## INFO-TECH n. 01/19 – 08/10/2019

### X30 Supply Variations

*New con-rod complete assy p.n.: ENC50100-C*

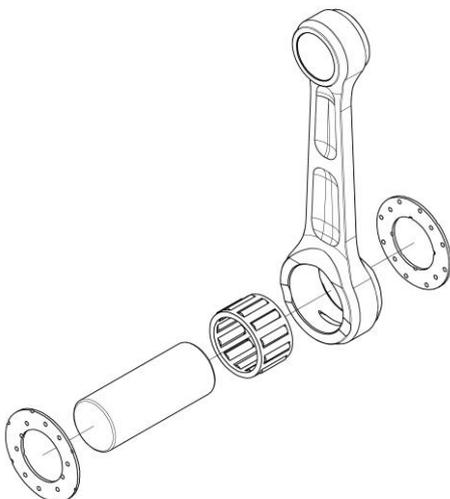
The round con-rod washers are going to be supplied as standard equipment.

Following the modification described above, two supplementary slots for lubrication are added on the con-rod's lateral planes.

The current washers (star shaped) and the current con-rod remain usable indefinitely.

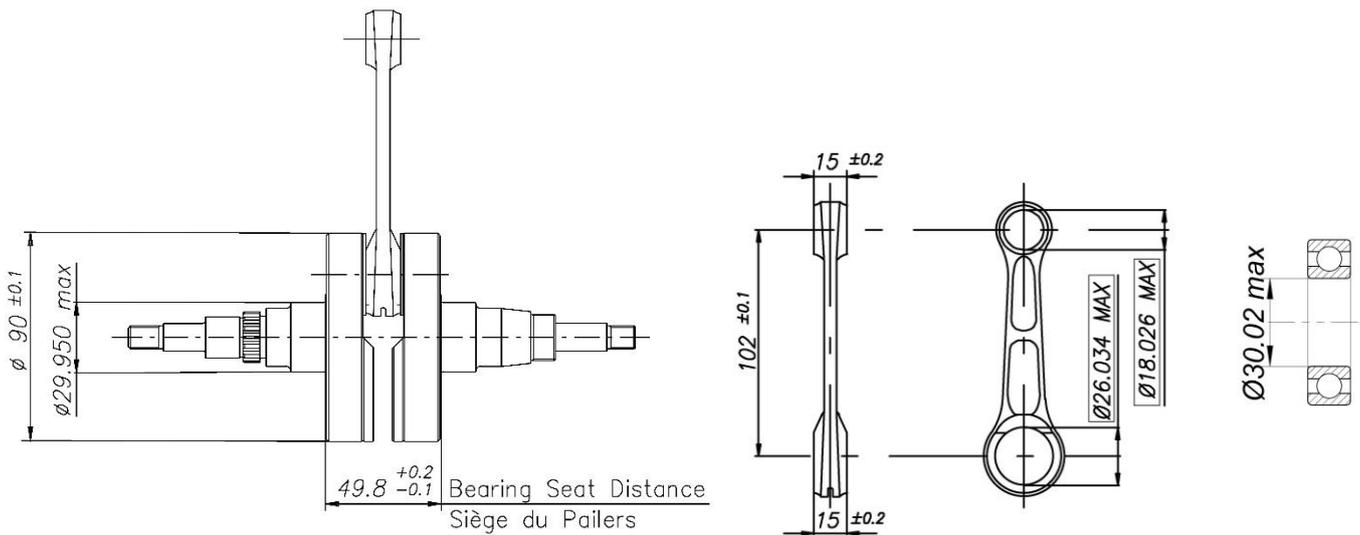
In order to stop the failures caused by intentional material removal or lack of maintenance, some important limit dimensions are added to the engine's fiche:

Maximum diameter of con-rod big end = 26.034mm

Maximum diameter of con-rod small end = 18.026mm

Minimum diameter of crankshaft journals = 29.950mm

Maximum diameter of main bearings' inner ring hole = 30.02mm

The tolerance on the crankshaft width is changed to 49.8 -0.1/+0.2mm.

The a.m. limit dimensions have to be respected also on the existing engines.

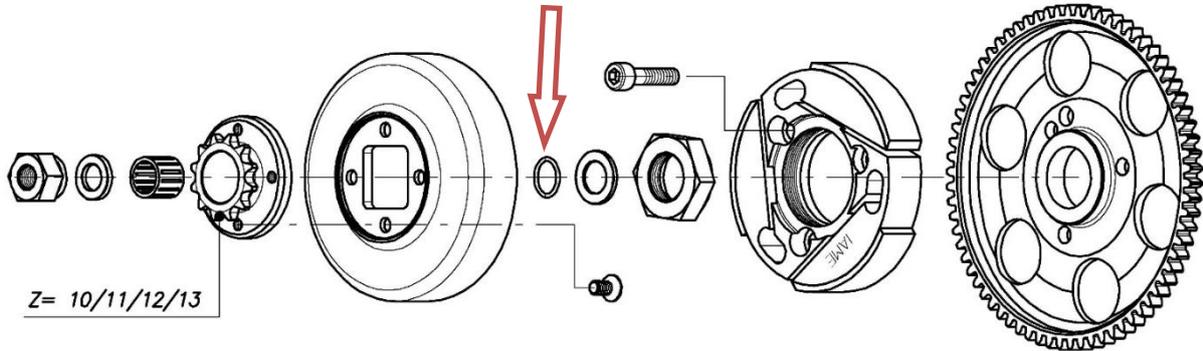
In order to prevent the contamination of the clutch drum inner part by grease, the use of the O-ring behind the clutch roller bearing is now compulsory, instead of optional.

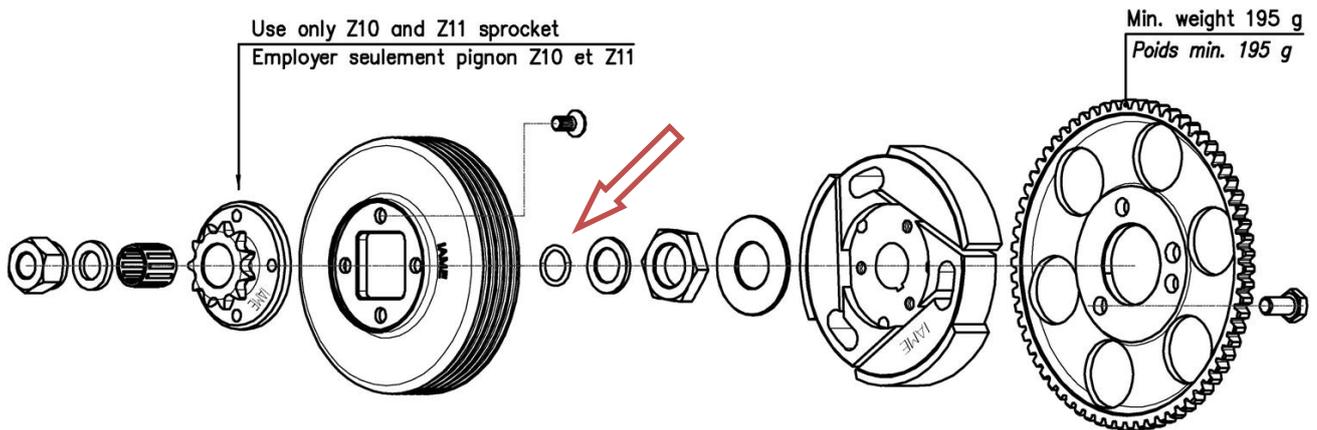
The clutch drums with holes is no longer allowed

In order to prevent the contamination of the clutch drum inner part by grease, the use of the o-ring behind the clutch roller bearing is now compulsory, instead of optional.

### \_Carburettors

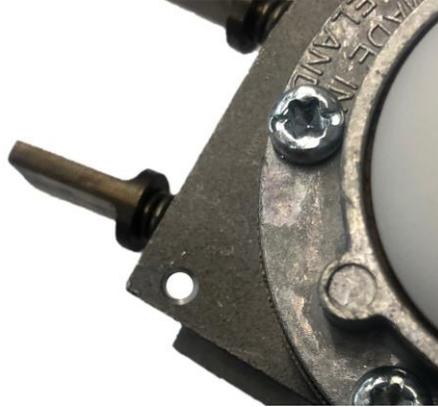
All the HW and HB carburettors will be provided with a supplementary 3mm hole in the body.

The hole is created to identify and seal the carburettor for the countries where this procedure is prescribed by regulations. It is not affecting the carburettor functioning in any way.
